# UNITED STATES PATENT AND TRADEMARK OFFICE

APPLICATION NO.	FILING DATE	FIRST NAMED INVENTOR	ATTORNEY DOCKET NO.	CONFIRMATION NO.
10/672,922	09/26/2003	Alex Ezra Cable	9314.0027	9462
22852	7590	06/25/2007		
FINNEGAN, HENDERSON, FARABOW, GARRETT & DUNNER LLP 901 NEW YORK AVENUE, NW WASHINGTON, DC 20001-4413			EXAMINER LUONG, VINH	
			ART UNIT 3682	PAPER NUMBER
			MAIL DATE 06/25/2007	DELIVERY MODE PAPER

**Office Action Summary**

**FIG. 1**

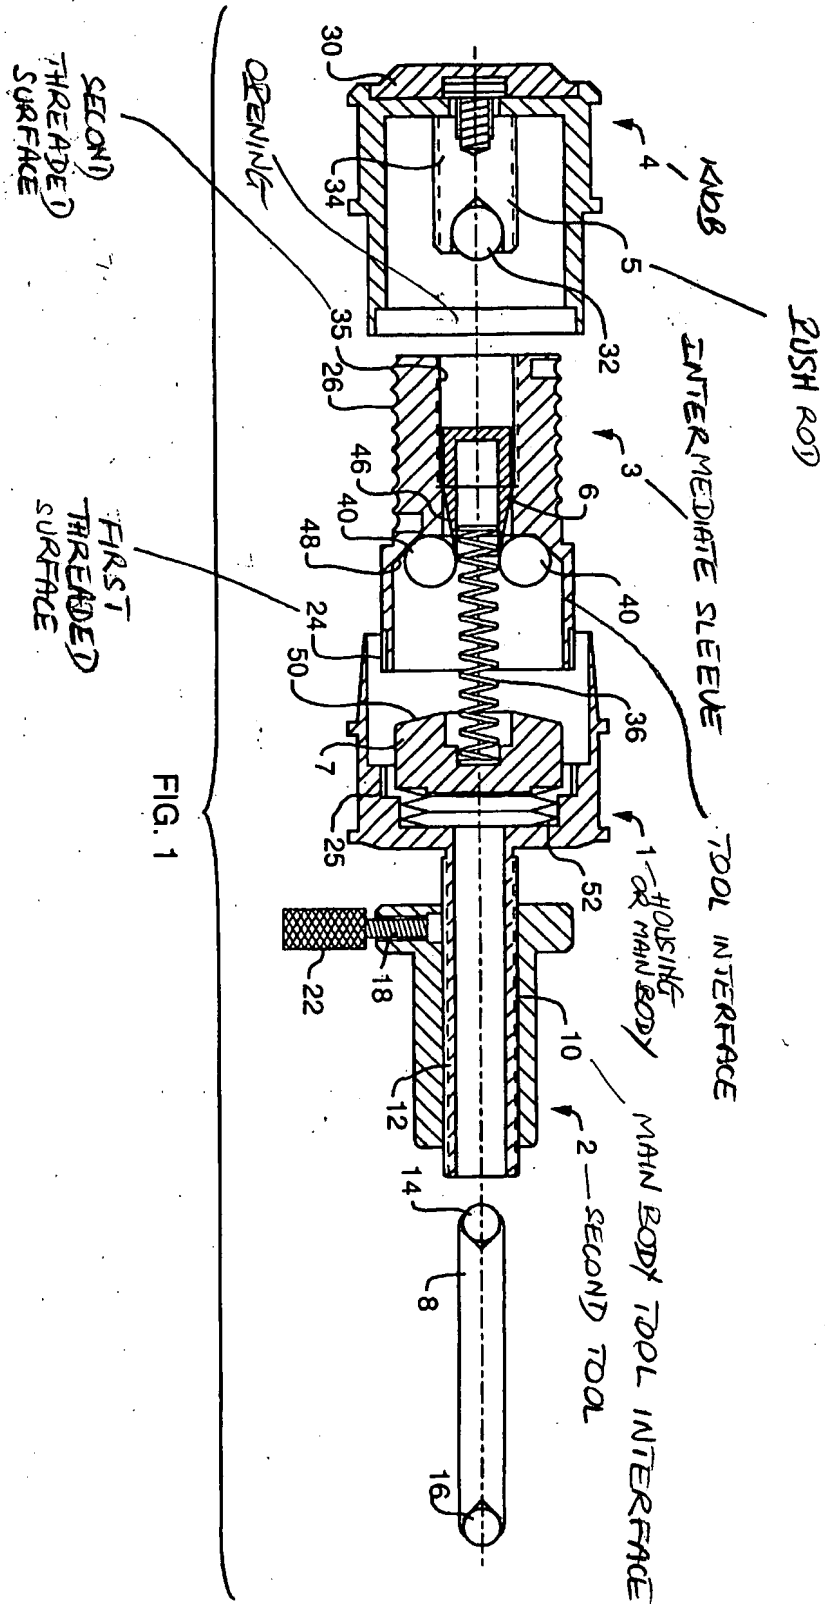
Regarding Claim 1, Cable teaches a differential adjuster, comprising: an intermediate actuator sleeve 3 with a first threaded surface 24, a second threaded surface 35, and a tool interface (at 48 in FIG. 1, see Attachment hereinafter "Att.").

Regarding Claim 5, the first threaded surface 24 is an external threaded surface and the second threaded surface 35 is an internal threaded surface. See FIG. 1.

Regarding Claim 41, the intermediate actuator sleeve 3 includes a tool interface (at 48 in FIG. 1, see Att.).

FIG. 2

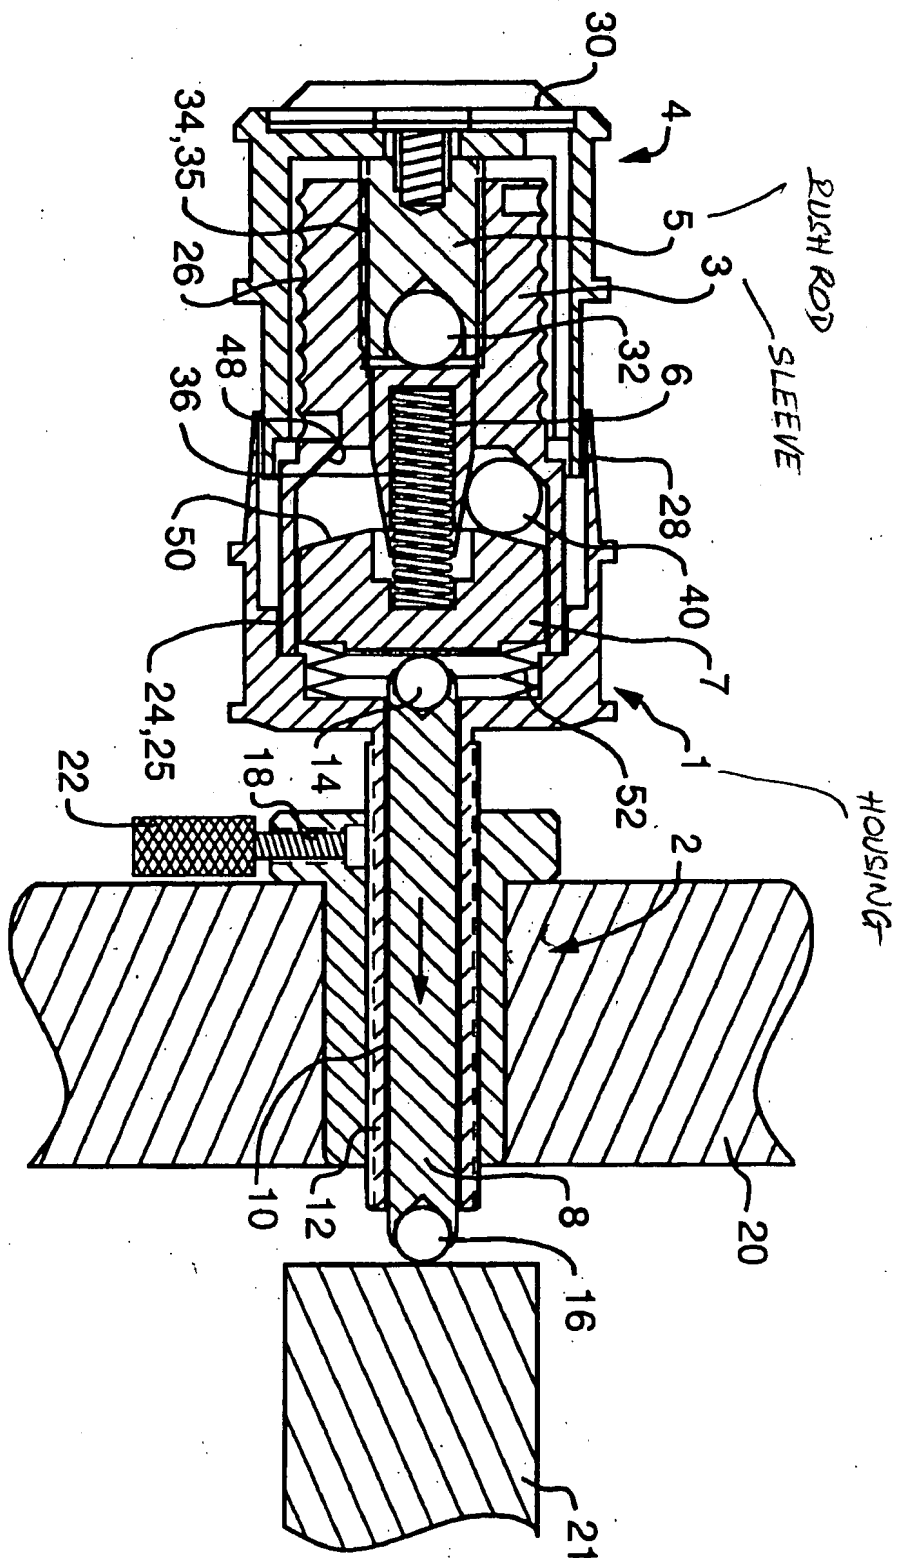
Regarding Claim 2, Cable teaches a rotationally constrained push rod 5 that engages the second threaded surface 35 (FIGS. 2 and 3), the push rod 5 moving at a rate related to the difference in pitch between the first threaded surface 24 and the second threaded surface 35 when the intermediate actuator sleeve 3 is rotated relative to a housing 1 that engages the first threaded surface 25. Cable, col. 2, line 6+. Moreover, note that referring the differential adjuster to the merely inferentially included element or intended use element, such as, the tool that engages the tool interface of the intermediate actuator sleeve is not accorded patentable weight.

Regarding Claim 3, the housing 1 and the push rod 5 are arranged so that the push rod 5 is capable of being rotationally constrained with respect to the housing 1. See FIGS. 2 and 3.

Regarding Claim 7, Cable's first threaded surface 24 is equivalent to the internal threaded surface 25 (FIG. 2) and Cable's second threaded surface 35 is equivalent to the external threaded surface 26. See MPEP 2144.06 *supra*.

Regarding Claim 25, the housing 1 is a component mount or positioner that engages the first threaded surface 24 of the intermediate actuator sleeve 3 (FIGS. 2 and 3).
